PARENT PARCEL: 18-00-021-112-050, -062, -063, -066, -072, -074, -076, -089, -103  
CHILD PARCEL: XX-XX-XXX-XXX-XXX  
STARTING POINT: XXXXXX

10-02100-C

SPLITS/DEEDS PROCESSED

LORAIN COUNTY TAX MAP DEPARTMENT  
226 MIDDLE AVE. ELYRIA, OHIO

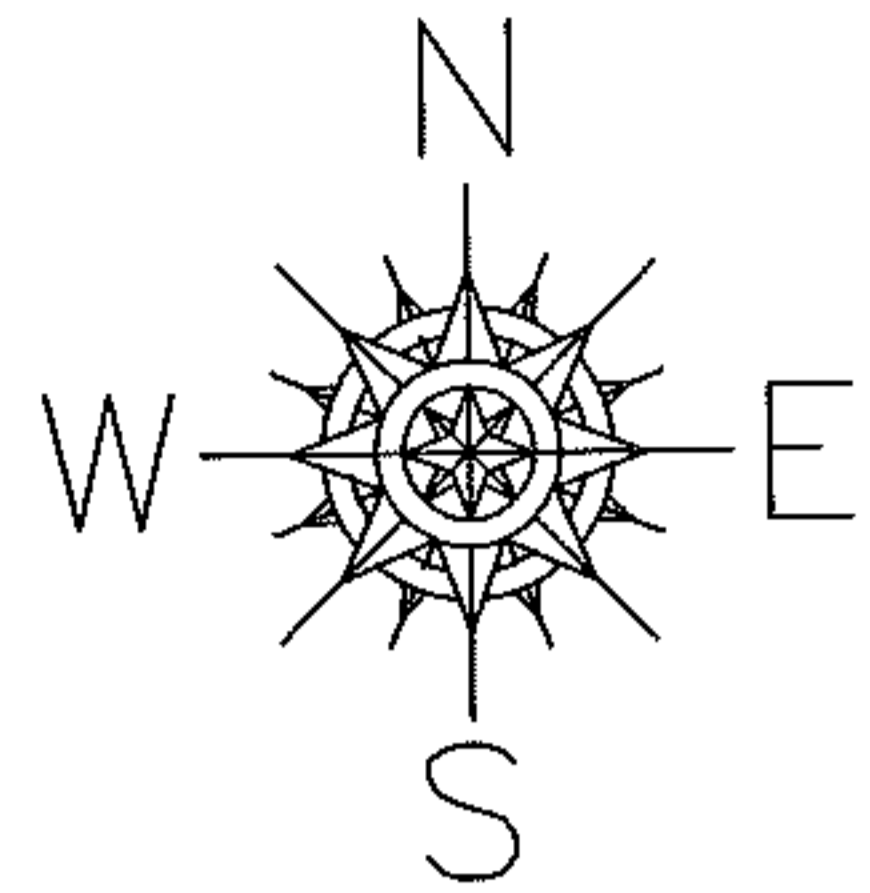
UPDATE LEGAL

18-00-021-112-062  
18-00-021-112-063  
18-00-021-112-074  
18-00-021-112-103  
18-00-021-112-089

SURVEY BEFORE NEXT TRANSFER,

ORIGINAL D.D. ANDRUS SURVEY INCORRECT  
MAKES CALL FOR SOUTH LINE OF CHURCH,

SOUTH LINE IS 165' SOUTH OF THE N.W. CORNER OF S/L 24  
S/L WAS DRAWN WRONG ON OLD MAP AND BAD SURVEY FOLLOWED  
INCORRECT SUBLOT DRAWING  
SEE DV 746/160

UPDATE LEGAL

18-00-021-112-076  
REVERT LEGAL BACK TO  
PRIOR, DV. 842/434

UPDATE LEGAL

18-00-021-112-066  
REVERT LEGAL BACK TO  
PRIOR, DV. 317/99-100

UPDATE LEGAL

18-00-021-112-050  
SHOULD BE PART OF S/L 25 ALSO

UPDATE LEGAL

18-00-021-112-072  
SURVEY BEFOR NEXT TRANSFER  
PRIORS NEVER HAD DIMENSIONS  
NEW DEED DOES  
CALLS FOR 62.25' DEED, CALC. 59.75'
